Agenda Summary Report (ASR)

Franklin County Board of Commissioners

AGENCY COMMENTS (SHORT PLAT 2021-24, Tallett)

SP 2021-24 Tallett

SHEET_1

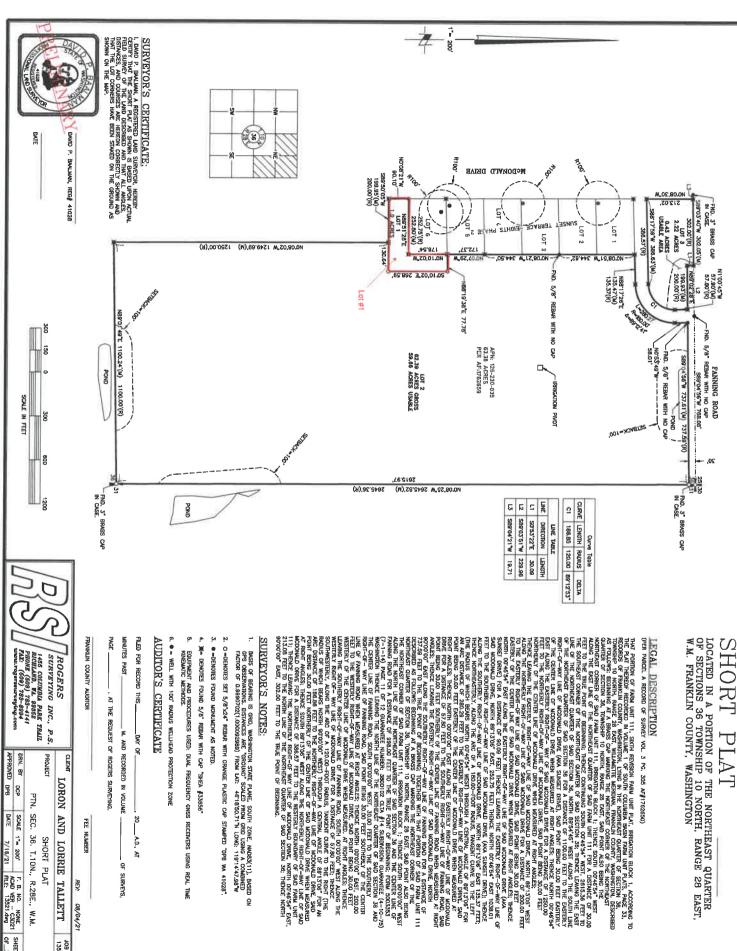
- 1 Per RCW 36.86.010, Terrace Drive shall be shown on the plat as dedicated along the southern 30 feet of Lot #2.
- The Owner's Certificate shall include wording for the dedication of road rights-of-way as described in Franklin County Code Section 16.24.030(K).
- 3 State Plane Coordinates conforming to Franklin County Code Section 16.28.100(C)(1) and as set forth by state statues for recording coordinates as described in RCW 58.20.180 were not submitted.
- 4 Per Franklin County Code 16.32.040(D)(9) and/or RCW 58.09.080, Certificates shall appear as follows:

- Pursuant to RCW 58.17.310, all parcels associated with this plat must have access to the legal point of irrigation water delivery to Farm Unit 111 of Irrigation Block 1. This point is at the intersection of the eastern parcel boundary of "Lot 2" and the PP4.9 irrigation lateral. Lots 1 and 3 must benefit from a minimum of a 10' wide irrigation easement to the point above. Additionally, a 10' wide irrigation easement must be extended from the above point to benefit lots 1, 2, 3, 4, 5, and 6 of "Sunset Terrace heights Phase 2" along the western edge of the proposed "Lot 2". Alternatively, the agricultural water allotment for these lots can be released which would relieve them of the access requirement. Contact the South Columbia Basin Irrigation District for more information.

- The PP4.9 irrigation lateral must be shown on the plat.
- The PP5.3 irrigation lateral must be shown on the plat.

On my letter I mentioned a well on 1681 Fanning Rd that is not shown on the plat, this did encumber the .43 acres you are showing as usable, that's' why it was important to be shown in addition to it being within 150' of the plat.

- 1. Each proposed lot must contain a minimum gross land area of 1 acre, and 15,000 square feet of usable land area after all easements and encumbrances are subtracted. Please note that slopes in excess of 20% are not calculated in the usable land area.
- 2. The following items **must** be located on the plat map:
 - a. All easements including utility, access.
 - b. All wells within 150' of the plat including the 100' well protection radius. (1681 Fanning Rd well encumbers proposed lot 2)
 - c. All slopes in excess of 20%.
 - d. All surface water including irrigation canal or pond within 100' of plat.
- 3. Proposed lot 2 usable land area must be designated on the plat.
- 4. A copy of the final proposal must be reviewed and approved by this office for final comments to the Franklin County Planning Department prior to final approval and signature.
